Subject: Duke Energy Carolinas, LLC
William States Lee III Nuclear Station – Docket Nos. 52-018 and 52-019
AP1000 Combined License Application for the
William States Lee III Nuclear Station Units 1 and 2
Supplemental Response to Request for Additional Information (eRAI
5507)
Ltr# WLG2012.06-03

Lee Nuclear Station Supplemental Response to Request for Additional Information (RAI)

Reference NRC RAI Number(s): 02.04.12-020

Revision to FSAR Chapter 2 Figures 2.4.12-209, 2.4.12-210, and 2.4.12-211

COLA Part 2, FSAR Figure 2.4.12-209 is revised as shown:

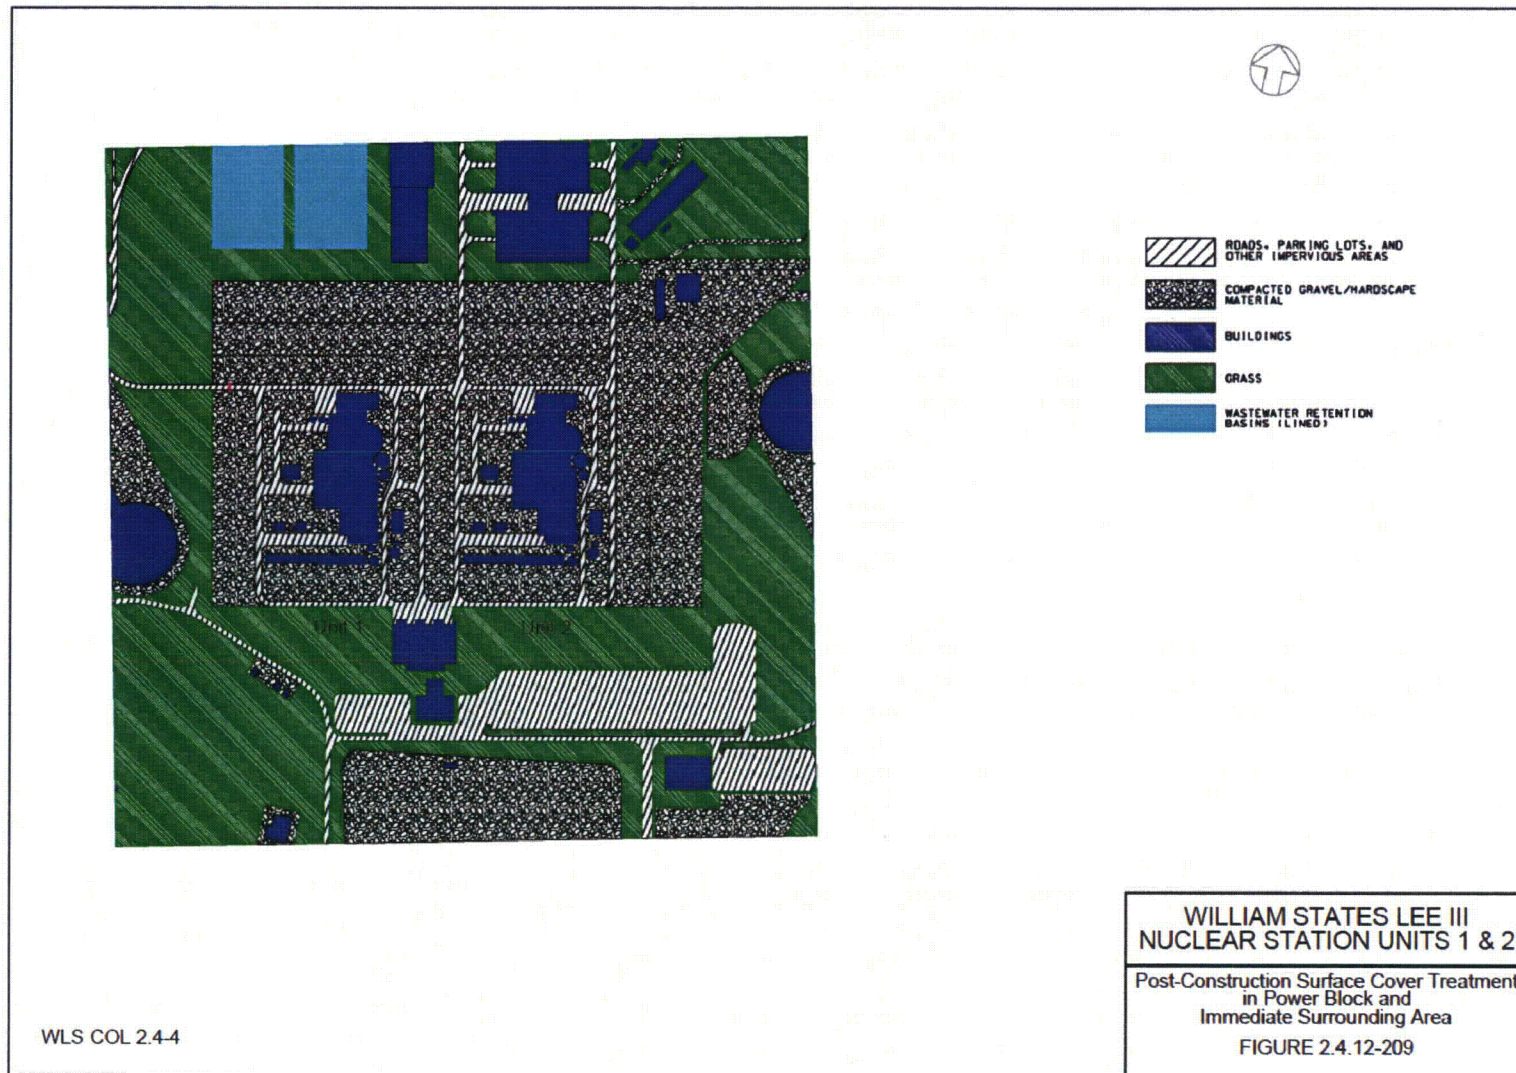
Additional information regarding maximum post-construction groundwater elevations at the Lee Nuclear Site is required to meet the requirements of 10 CFR 52.79(a)(1)(iii), 10 CFR 100.20(c), 10 CFR 100.21(d), and GDC 2. The applicant's past estimates based on observed water levels in the Cherokee excavation and generalizations based on LeGrand (2004) are insufficient, since they do not sufficiently take into account the actual conditions that are anticipated to exist after construction. Staff needs an estimate of the maximum post-construction groundwater level that is based on anticipated post-construction surface conditions, and also on a plausible conceptual model of the post-construction subsurface conditions. The estimate must be based on recharge rates associated with each of the main surface features, including semi-impervious surfaces, grass-covered surfaces, drainage ditches, and the cooling tower mounds. The estimate must address groundwater response to the maximum plausible recharge rates and to potential groundwater mounds that might form, e.g., beneath the cooling towers and drainage ditches. The groundwater response must account for the post-construction subsurface conditions, including engineered fill and backfill. The area of interest is bounded approximately by the 588-ft contour just north and south of Units 1 and 2, as shown in COLA Rev. 2, FSAR Fig. 2.4.2 202, and bounded east and west by the cooling towers.

In addition, there are improvements to the site regarding surface cover treatment, which promotes additional runoff, further reducing the extent of groundwater recharge. A revised FSAR Figure 2.4.12-209 (see Attachment 1) shows the updated surface cover treatment plans for the site. Key changes in surface cover treatments that have been updated in the groundwater analysis include the following:

- Addition of lined wastewater retention ponds to the northwest of the power block,
- Representation of the cooling towers and associated hardscape coverage to the east and west of the power block,

- Increased application of hardscape to the immediate north of the power block (in the area of the heavy haul road),
- Change of brush areas, southwest of Unit 1, to grass coverage,
- Representation of the parking lots to the south of the power blocks, and
- Application of hardscape to the switchyard area to the south of parking lots.

COLA Part 2, FSAR Figure 2.4.12-210 is revised as shown:

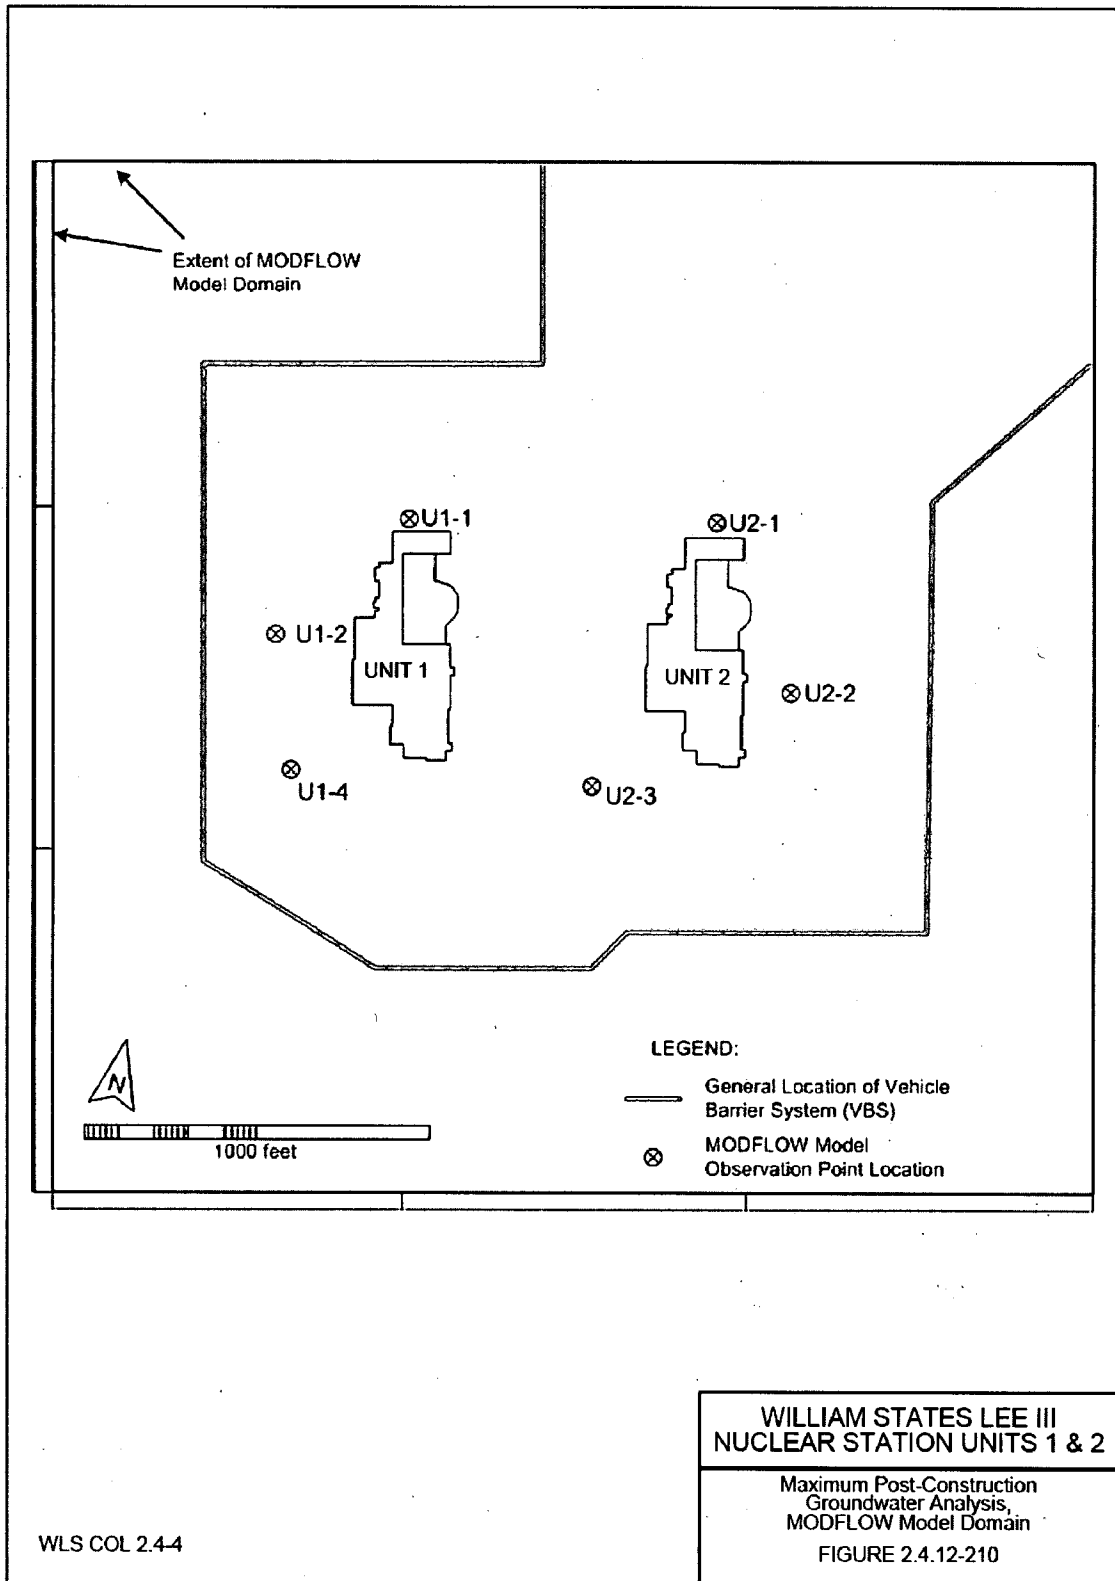
In Reference 3, the limiting observation point was designated "U1-3." In the current analysis, the location of this point is re-located (slightly to the north-northwest of the prior position) to obtain a more conservative result. This new point is designated "U1-4." The maximum post-construction groundwater level, from the Representative Case (as defined in Reference 3), results in an estimated groundwater level of 581.39 ft. msl at the southwest observation point (U1-4). (This value is slightly lower than the estimated maximum level of 582.22 ft. msl, determined at the prior southwest observation point, U1-3, reported in Reference 3.)

Revised FSAR Figure 2.4.12-210 (see Attachment 1) shows the location of the model domain, power block locations, and designated observation points.

COLA Part 2, FSAR Figure 2.4.12-211 is revised as shown:

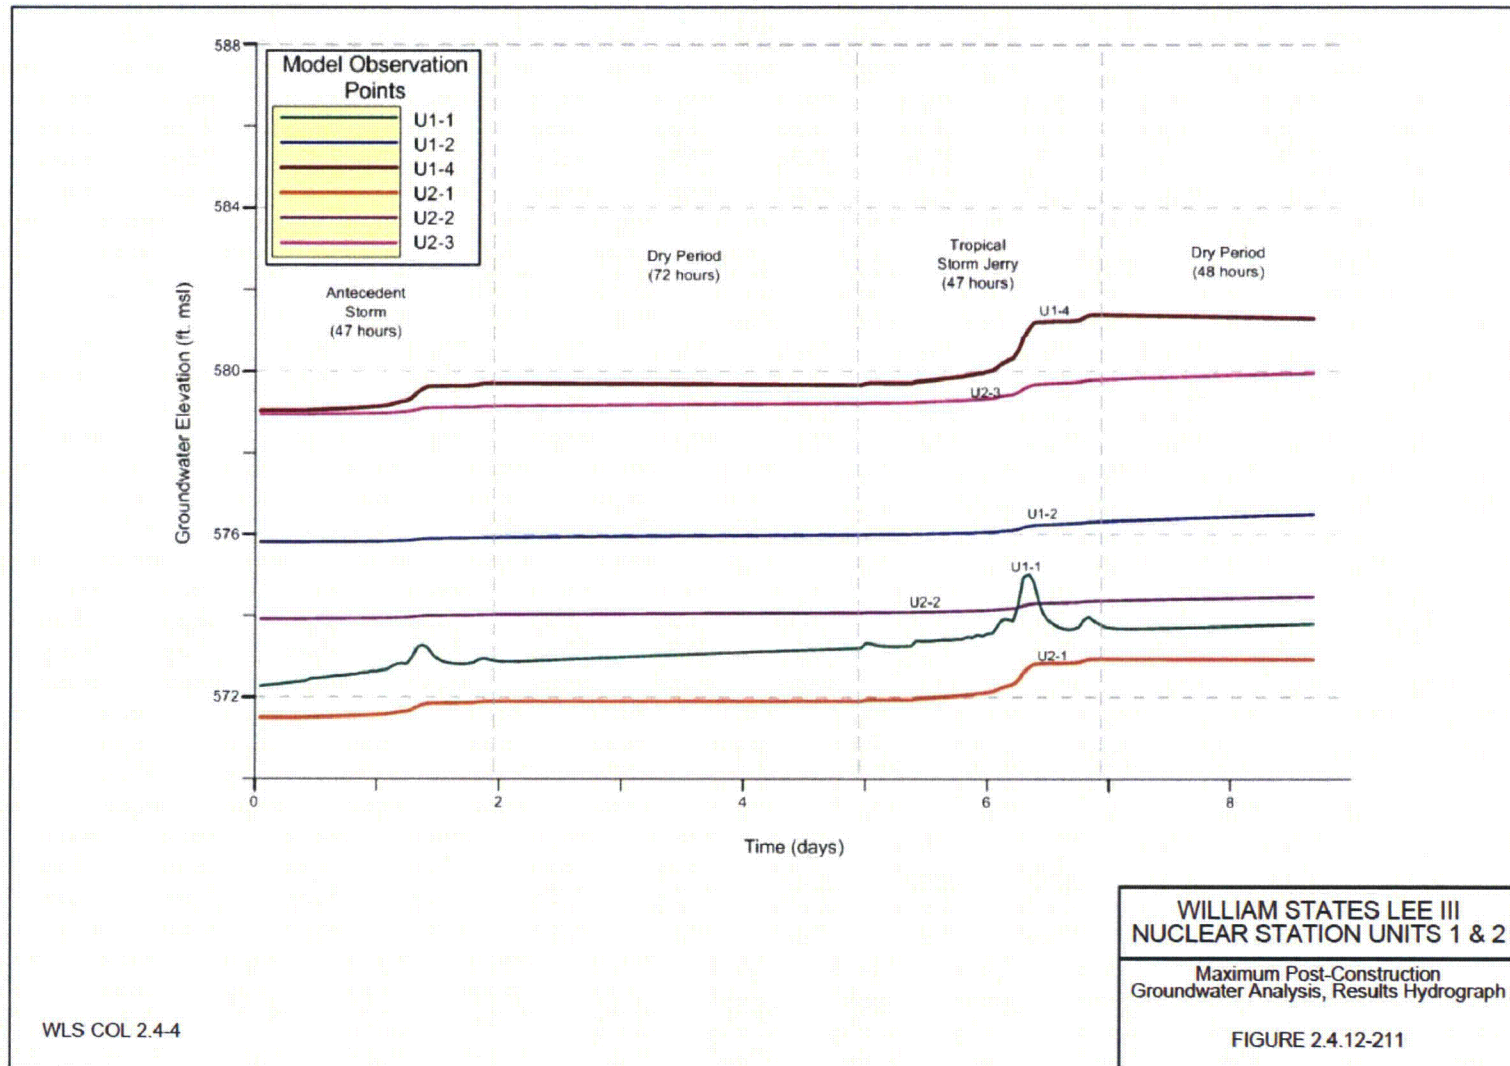
The numerical analysis described in Reference 3 was updated (1) using corrected runoff values, and (2) reflecting the above improvements to surface cover treatments. The changes in ground surface treatments improve runoff and decrease recharge in this updated analysis. Generally, the revised analysis shows a reduction in the estimated maximum post-construction groundwater levels. The limiting observation point in the model remains in a location to the southwest of Unit 1.

Revised FSAR Figure 2.4.12-211 (see Attachment 1) illustrates the updated hydrograph traces for all observation points for the Representative Case over the model duration.
